**BEFORE THE PUBLIC UTILITY COMMISSION
OF OREGON**

Docket No. LC 82

2023 Integrated Resource Plan.

OPUC Staff Opening Comments

Figure 3: Meeting PacifiCorp’s Capacity Needs with Preferred Portfolio Resources – PacifiCorp Integrated Resource Plan.³⁰

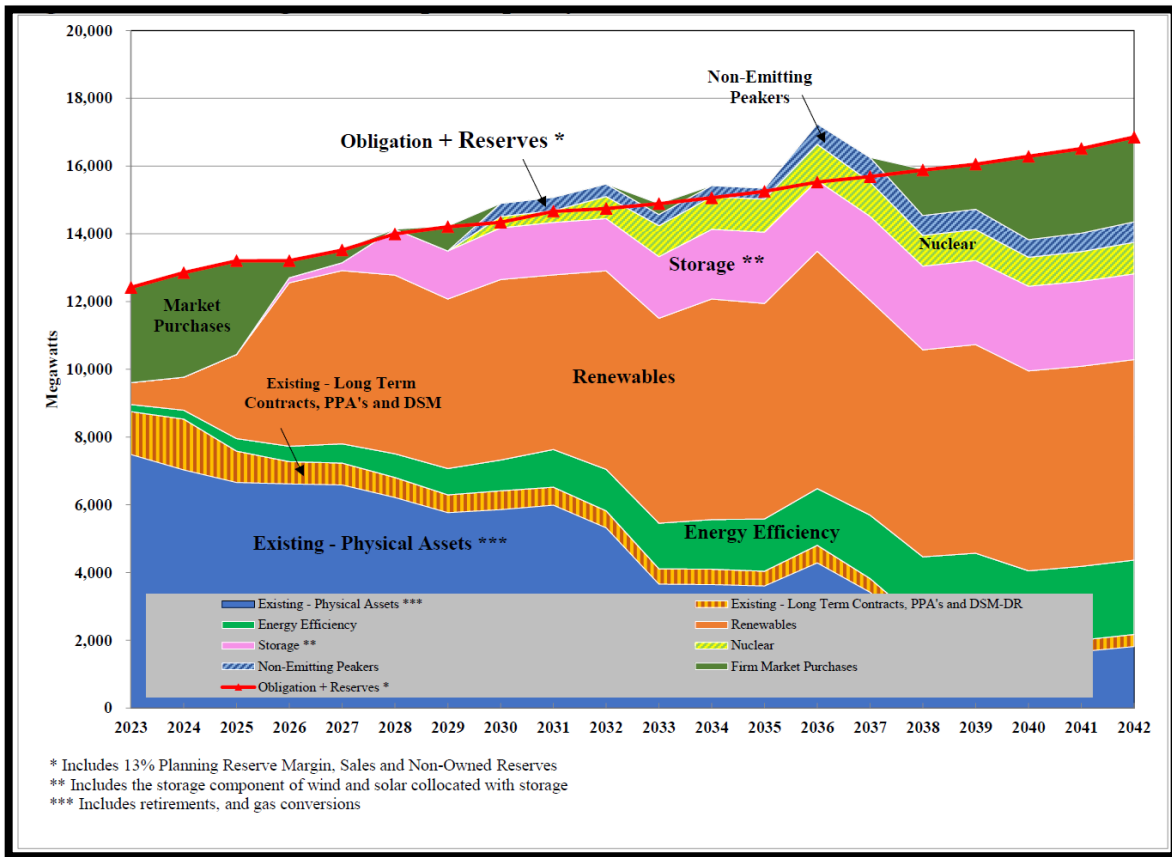
As noted in several places previously, the 2023 IRP Preferred Portfolio seeks to add sizeable amounts of new generation over the next decade and beyond. The economic, reliability, and emission reduction benefits from adding so many resources over the next twenty years was so pronounced that PacifiCorp identified that the main procurement risk to this IRP was not over procurement, but rather the inability to procure enough resources in the required timeframe.²⁷ The Company's recent suspension of the 2022 AS RFP casts a shadow of uncertainty over the action plans, much of the IRP's supporting analysis, and the CEP compliance pathways put forth.²⁸ Further, the near-term acquisition of new resources also reduced one of the IRP's greatest sources of risk: market reliance to meet increasing load.²⁹

Staff’s requests that PacifiCorp’s reply comments describe how this delay impacts such things as the Preferred Portfolio’s composition and NPVRR; the risk to HB 2021 compliance by 2030, if other investments are being similarly delayed; and if/when the RFP will move forward. Further, Staff hopes to better understand how realistic is this level of reliance on near-term renewables; what is the impact to such avoided cost elements as capacity for DSM and PURPA resources; the consequences of prolonged market purchases continuing past 2025; and, what alternatives should arise given these risks.

Figure 4: Portfolio Variant Performance

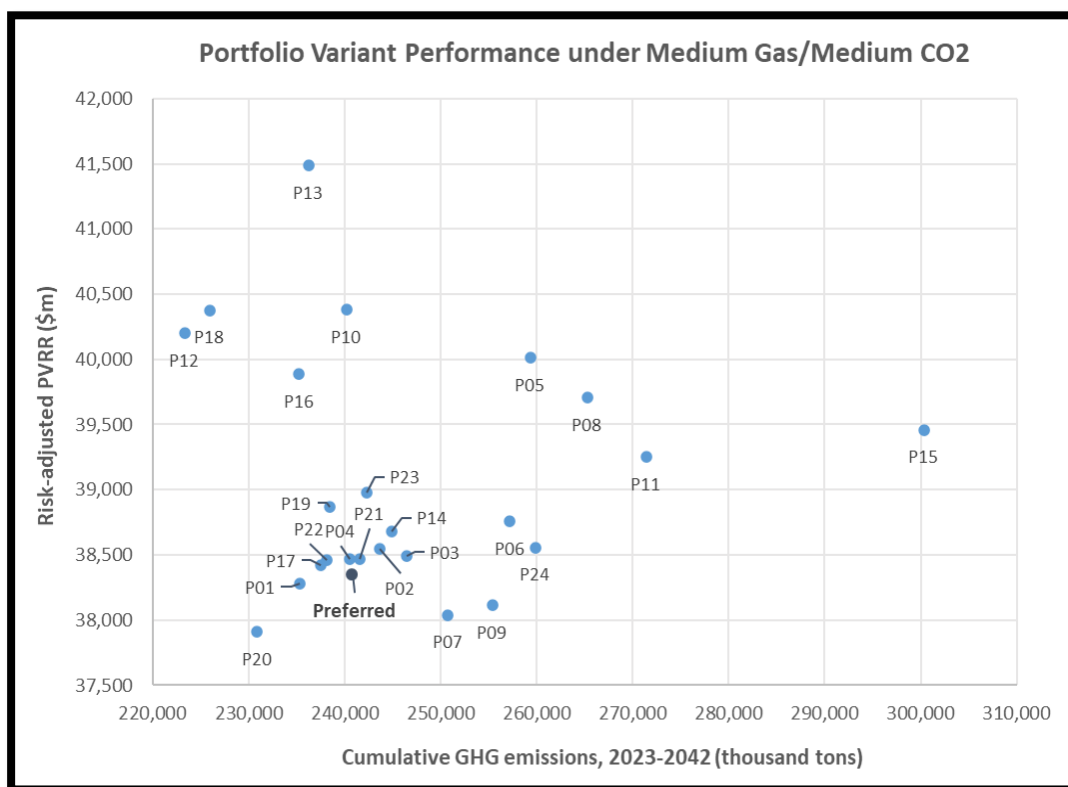
The IRP provides analysis of 24 Preferred Portfolio variants that test alternative strategies for coal (retirement, conversion to gas, and retrofit with CCUS) and reliance on nuclear, non-emitting peakers, offshore wind, transmission, and DSM. PacifiCorp also tested six sensitivities with varying load growth and private generation forecasts. The Company presented key scoring metrics, including PVRR, risk-adjusted PVRR, cumulative Energy Not Served (ENS), and cumulative GHG emissions for each portfolio under Medium Gas/Medium CO₂ price assumptions and a subset of the portfolios under alternative gas and GHG price assumptions. Figure 4 below shows the performance of the variant portfolios under medium gas and CO₂ prices based on information in Table 9.14 of the IRP.⁸⁷ Only two of the variant portfolios (P01 and P20) achieve both lower risk adjusted PVRR and cumulative GHG emissions relative to the Preferred Portfolio. P01 reflects early coal-to-gas conversion of Jim Bridger units 3 and 4 (2026, rather than 2030), and P20 reflects conversion of Jim Bridger units 3 and 4 to CCUS in 2028.

With regard to Jim Bridger 3 and 4, under Medium Gas/Zero CO₂ price assumptions, accelerating coal-to-gas conversion from 2030 to 2026 increases the risk adjusted PVRR by \$152M, relative to the Preferred Portfolio.⁸⁸ PacifiCorp therefore does not consider P01 to be preferred over the Preferred Portfolio and states that because of this finding, “future policy risk

Figure 6 Forecasted Retail Sales Growth in Oregon, Post-DSM (MWh) Total

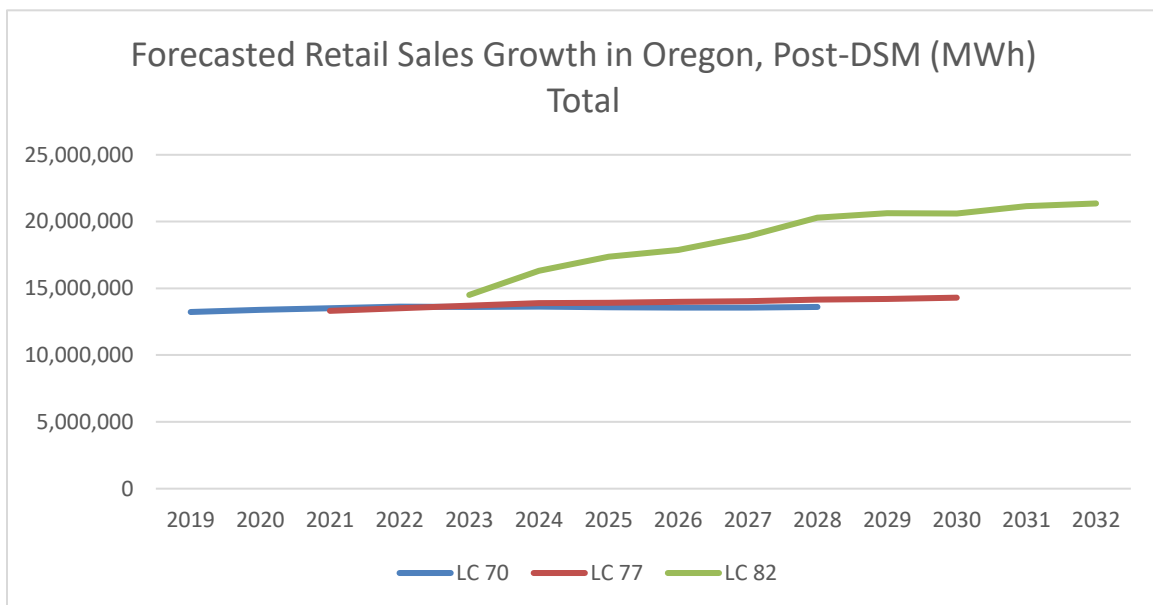
Between 2023 and 2032, PacifiCorp has forecast load to increase by 47 percent within its Oregon service territory. This forecast represents a stark deviation from the trend of forecasted load growth presented by the Company in previous year’s IRPs (Figure 6).

The most significant factor driving the increased load is the Company’s commercial load forecast which estimates commercial load in Oregon to increase 88 percent by 2032. This forecasted increase estimates that commercial retail sales will become 61 percent of total retail sales in Oregon by 2032, up from 48 percent in 2023 (Figure 2). The Company states in the IRP that “Changes to PacifiCorp’s load forecast are driven by higher projected demand from new large customers driving up the commercial forecast and an increased residential forecast.”⁹² Beyond this statement, the Company offers no further detail within the text of the 2023 IRP Appendix A to explain why such an increase can be reasonably expected through 2032.

Figure 7: Forecasted Share of Oregon Retail Sales

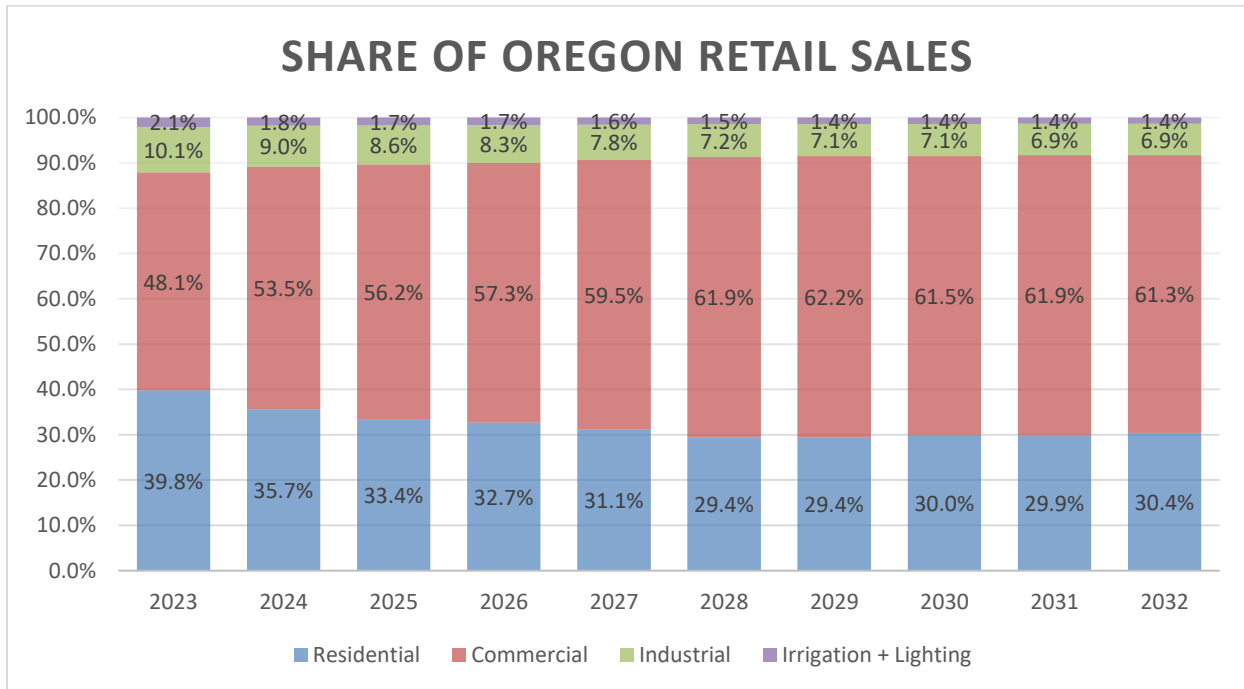
PacifiCorp fails to provide sufficient detail on how exactly input from RBMs are incorporated into the commercial sales forecast, and whether these “lumpy” changes in commercial sales such as new projects can be reasonably expected to come online over the period put forth by the Company in the commercial forecast.

Given that the expected increase in commercial load is the most significant factor driving the increase in the Company’s overall load forecast, Staff is concerned with the lack of detail provided by the Company on the exact nature of this load growth. Staff finds it difficult to determine whether the Company is overestimating or underestimating its load forecast. To better assess the accuracy of the forecast Staff would need greater detail on how these projects are incorporated into the model and whether they can be reasonably expected in the time frame laid out by the Company.

Figure 8 United State Bureau of Reclamation Site – “Klamath River near Seiad Valley”

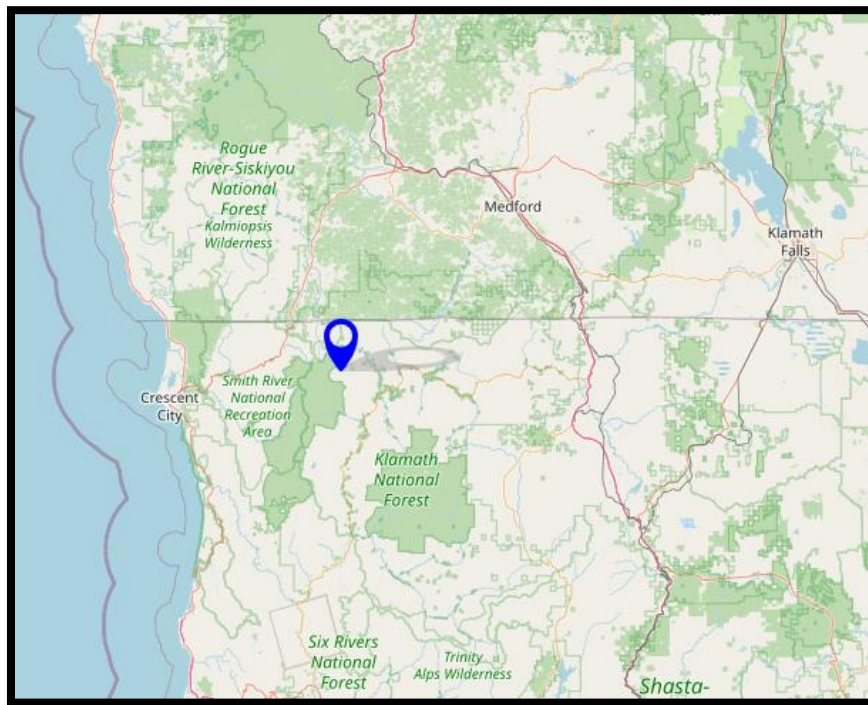
The Company uses the “Klamath River near Seiad Valley” Bureau of Reclamation Site for its projected range of temperate changes associated with Oregon. Staff notes, however, that this site is not located within Oregon (Figure 3).

Staff understands the Study estimates temperature and hydrologic impacts broadly across regions and that while this specific site may not be within Oregon it could still generally represent climate impacts in the west. However, Staff finds the Company’s selection of this site to represent projected temperature changes in Oregon odd, especially given the Company’s wide ranging service territory throughout Oregon (Figure 4).

Figure 11: Comparison of Oregon EE Acquisition in Preferred Portfolios from 2021 and 2023 IRPs¹³⁴

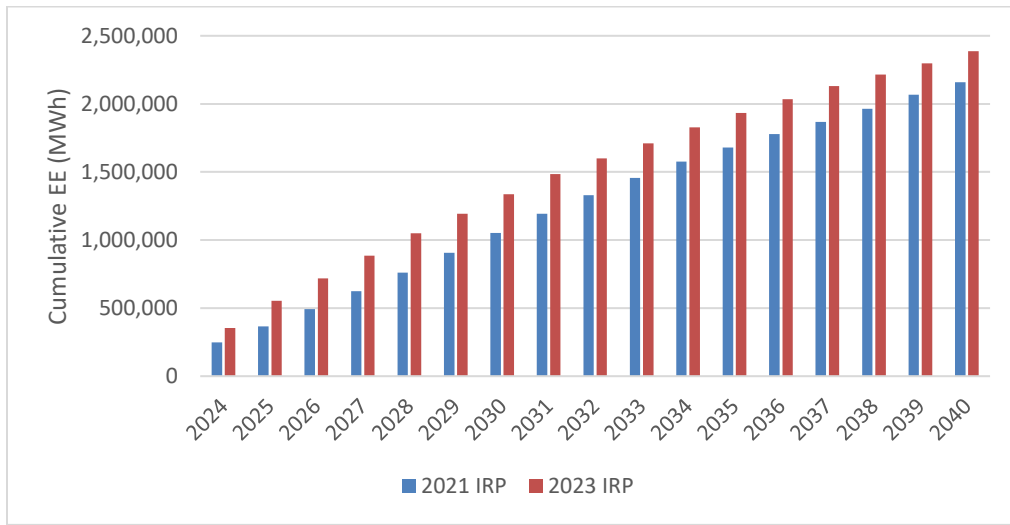
PacifiCorp identifies a sharp, near-term increase in the need for cost-effective energy efficiency (EE) in the Company's preferred portfolio. EE selection in the preferred portfolio is driven primarily by elevated and volatile forward market prices for electricity in the next three years. Cumulative EE acquisition between 2024 and 2030 increased by 28 aMW in the 2023 IRP compared to the Company's 2021 IRP.¹³³ Figure compares the Oregon acquisition of EE between the two IRPs. Notably, the 2023 IRP identifies a 61 percent greater EE need in the 2024 and 2025 EE acquisition. In response to identified needs, Energy Trust of Oregon is planning to scale investment and infrastructure to acquire higher levels of EE this decade.

Staff is encouraged to see PacifiCorp identify the significant short-term EE need, but concerned that the long-term acquisition is insufficient to meet the requirements of HB 2021.

Figure 12: PacifiCorp's Preferred Portfolio EE Acquisition and Cost¹³⁵

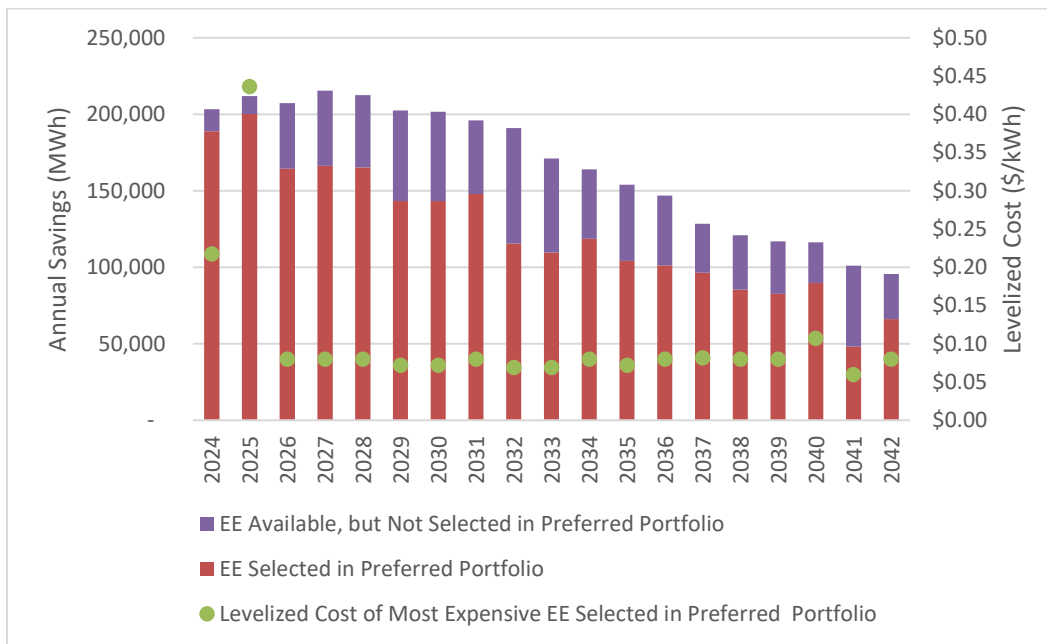
Figure demonstrates how over the planning period, PacifiCorp's preferred portfolio selects a lower percentage of available EE, with a low levelized cost for the highest cost EE resource. For example, in 2025 PacifiCorp identifies a need for 95 percent of the available EE, with the highest bin of EE selected having an average levelized cost of \$0.44/kWh. This compares to most subsequent years procuring maximum cost EE at an average levelized cost of less than \$0.10/kWh. This long-term decrease stands in stark contrast to the increasing resource needs in the IRP and steeply increasing costs associated with the CEP's compliance pathways. Staff finds that improvements to avoided costs may address this decline along with different assumptions about EE technology development curves.

Staff appreciates that PacifiCorp included a scenario that maximizes DSM resources, however Staff arrives at different conclusions than the Company. Staff takes issue with PacifiCorp’s use of the Max DSM scenario as an add-on to what is selected in the preferred portfolio (P-MM). PacifiCorp notes that the scenario does not change any other resource selections, indicating that all other supply side resources are still pursued as well as the additional DSM measures. Without consideration of avoided supply side investments as a result of the additional 4 GW of cumulative DSM identified by 2042, the scenario incorrectly evaluates cost relative to the preferred portfolio.
